Letter of Objection to the development at Former Tower
Car Sales, Tower Close, East Grinstead, West Sussex
(now known as Whittaker House, 1 Leppard Walk) and
retrospective application DM/26/0432

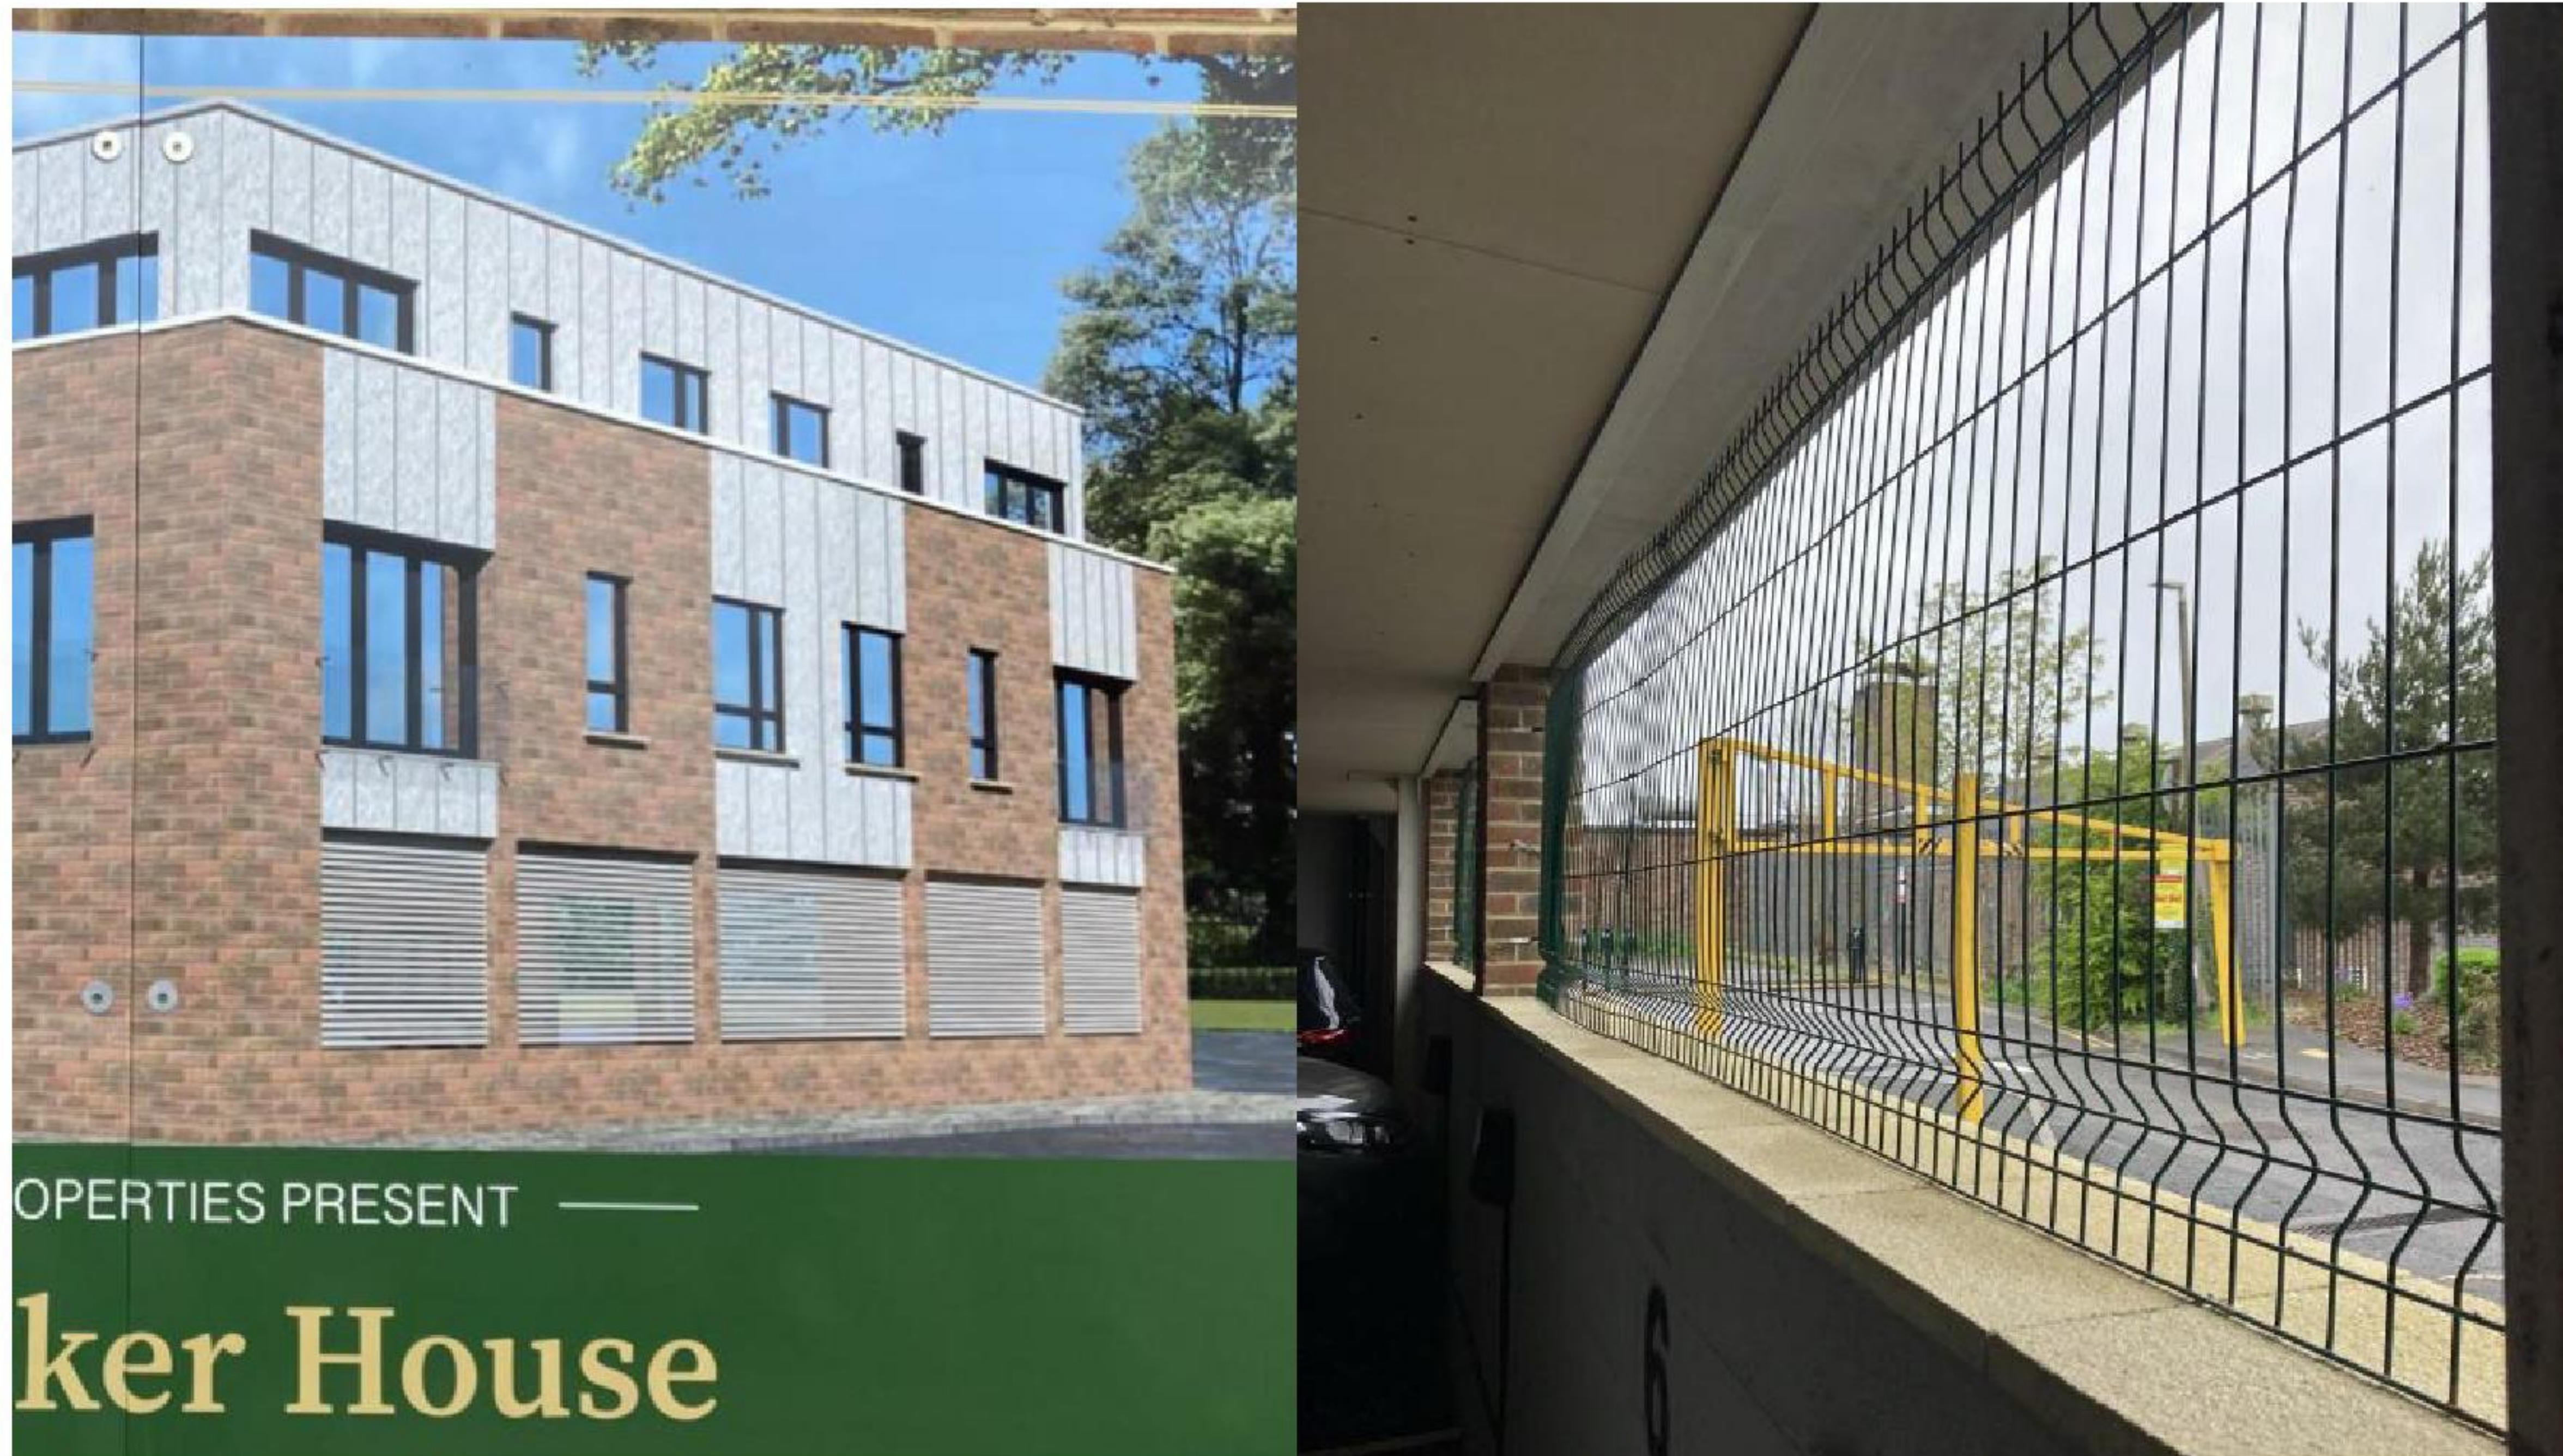
Planning permission for Whittaker House was granted on the expectation that residents would not need to enter through the undercroft, and they would have a dedicated entrance. This has also been sacrificed to make room for a potential 10th flat, with the entrance now located within the undercroft. None of the entry systems, neither internal nor external, have ever worked. The developer has been reached out to numerous times to correct this, but as of writing, no one in Whittaker House is able to receive guests, or secure deliveries, without either getting telephoned first or waiting outside the property. This is yet again more proof of the developers lack of character, and the disparity between what both we and the Planning Office were sold versus what was delivered.

The opaque glass has now been replaced with a back door, which accesses the bin and bike storage and takes us past Flat 1A's front door. The area under the stairs, which was supposed to be our hallway through to a front door, is now the cupboard where all our meters are stored. Further proof that the developer had no intention of building to plan, permission, or sales materials:

The sales poster for Whittaker House (also submitted in plans); The current car park grills

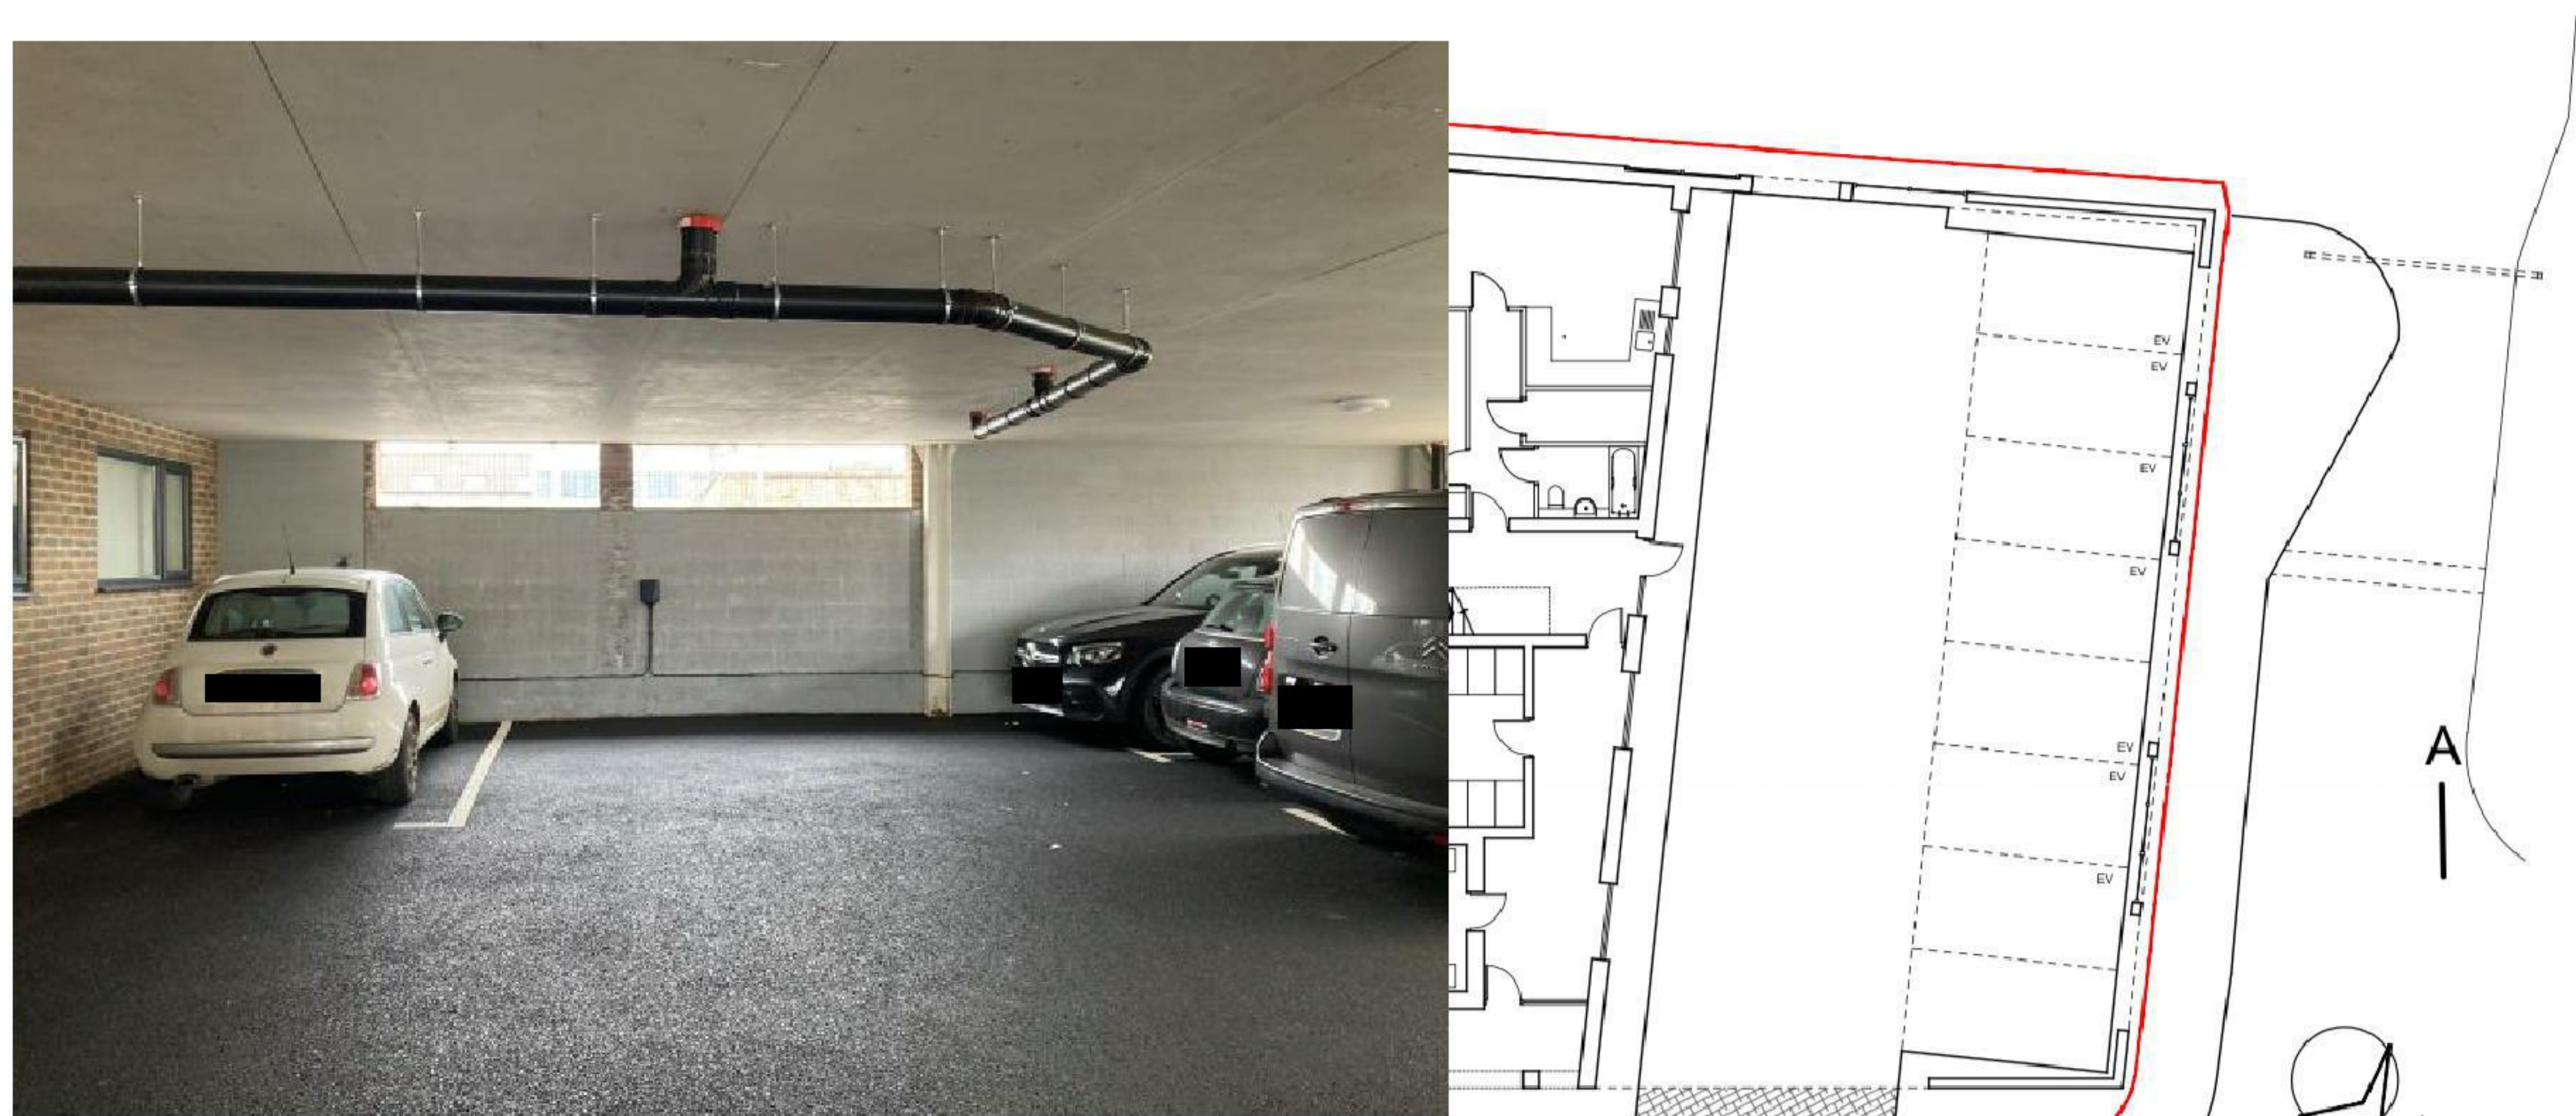
This was originally designated for 8 parking spaces, with tasteful exterior slats (or filigreed metal screens, depending on the submitted pictures). What we have been given more closely represents a snipers nest in Fallujah. This has a considerable effect on the exterior appearance of the building, and combined with the new front facing refuse area, significantly lowers the appearance of the neighbourhood:
